SUBJECT: NRC SPECIAL INSPECTION REPORT 05000247/2000-010
STEAM GENERATOR TUBE FAILURE

Report No. 05000247/2000-010

Facility: Indian Point 2 Nuclear Power Plant

Indian Point 2 Nuclear Power Plant NRC Inspection Report 05000247/2000-010

Figure 8 - Contour of the crack in tube R2C5 in SG24 using the 1997 data from the mid-range plus-point probe.

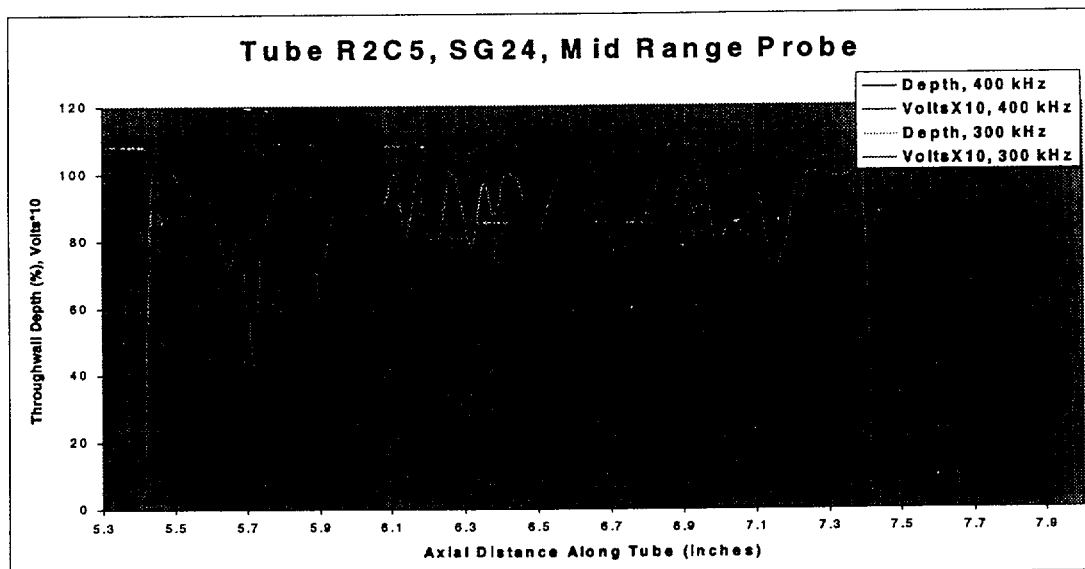
1. R2C5 in SG 24 - Figure 5 is a c-scan plot of the vertical component of the ECT voltage signal. The defect signal, indicated by the arrow, sits on a noise ridge that runs the length of the tube. This noise ridge is about 1-volt in amplitude and measures as a deep ID defect. This ridge makes both the detection and sizing of this defect more difficult. Figures 6 and 7 are the lissajous plots for the flaw area and the noise ridge, respectively. These figures show that a flaw signal is distinguishable from the characteristic noise signal, as was the case in the other tubes profiled. No year 2000 data is available since the tube failed.

The indication has been profiled for both the 300 and 400 kHz inspection frequencies, as is shown in Figure 4. The signal-to-noise is slightly better for the 400 kHz frequency than for the 300 kHz. The voltage above 1.2-volts indicates the defect; however, there is considerable noise. The depth estimate based on 1997 data is 87% TW.
